**IN THE MATTER OF** an application submitted by the Department of City Planning pursuant to Section 201 of the New York City Charter, for an amendment to Article VIII, Chapter 1 (Special Midtown District) of the Zoning Resolution of the City of New York, concerning the establishment of the East Midtown Subdistrict, Borough of Manhattan, Community Districts 5, 6, and 8.

This application (N 170186 ZRM) for a zoning text amendment was filed by the Department of City Planning on December 29, 2016, in conjunction with a related amendment to the Zoning Map to establish the East Midtown Subdistrict (the “Subdistrict”). On March 27, 2017, pursuant to Section 2-06(c)(1) of the ULURP rules, the Department filed an application (N 170186(A) ZRM) to modify the proposed amendment to the Zoning Resolution in response to recommendations heard during the public review. This modified application (N 170186(A) ZRM) is the subject of this report.

Map 1: Special Midtown District and Subdistricts

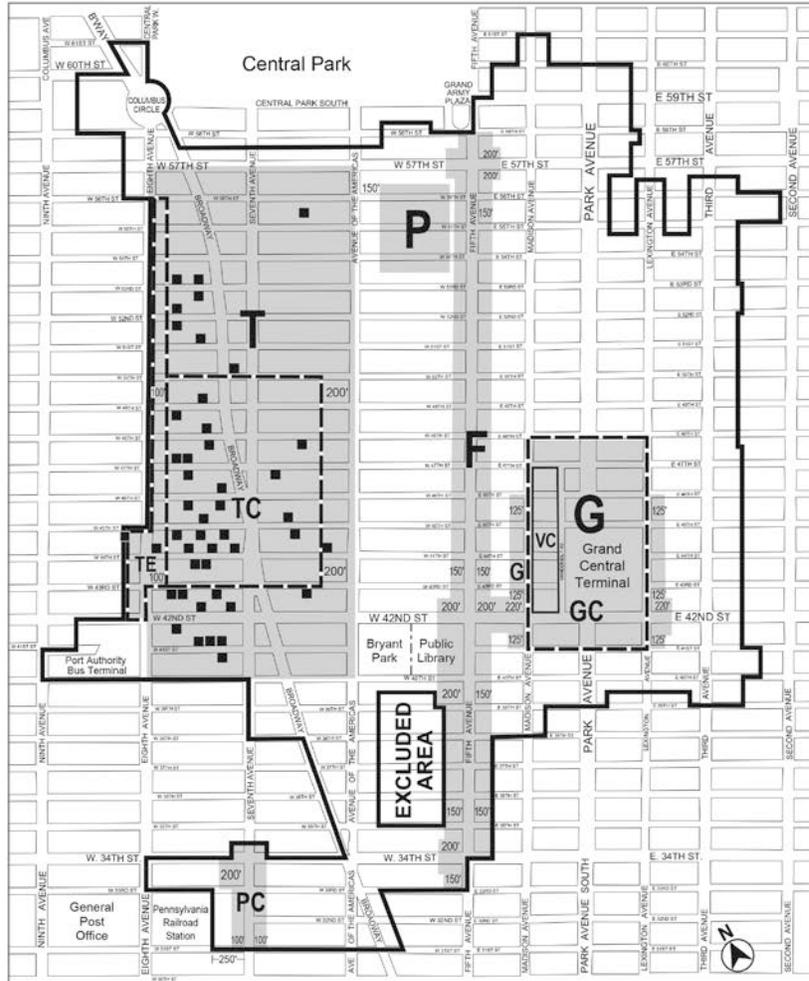
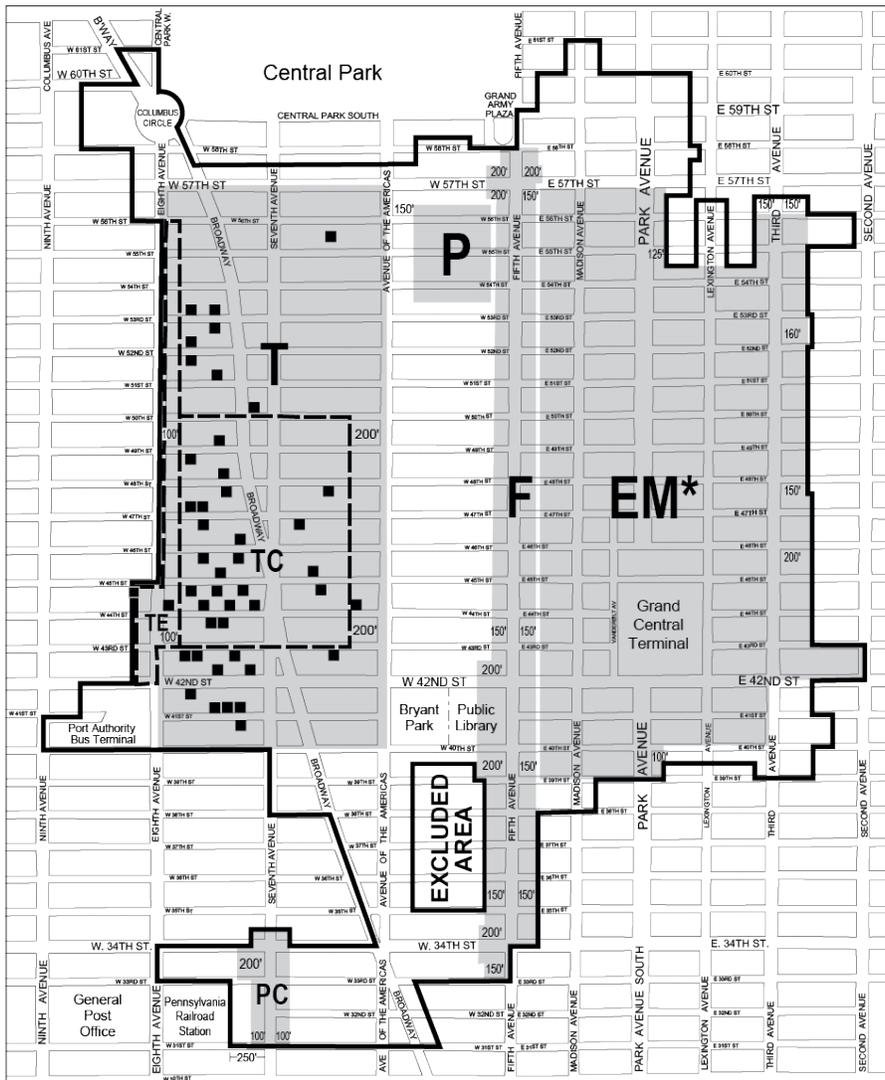
[EXISTING MAP]

[PROPOSED MAP]
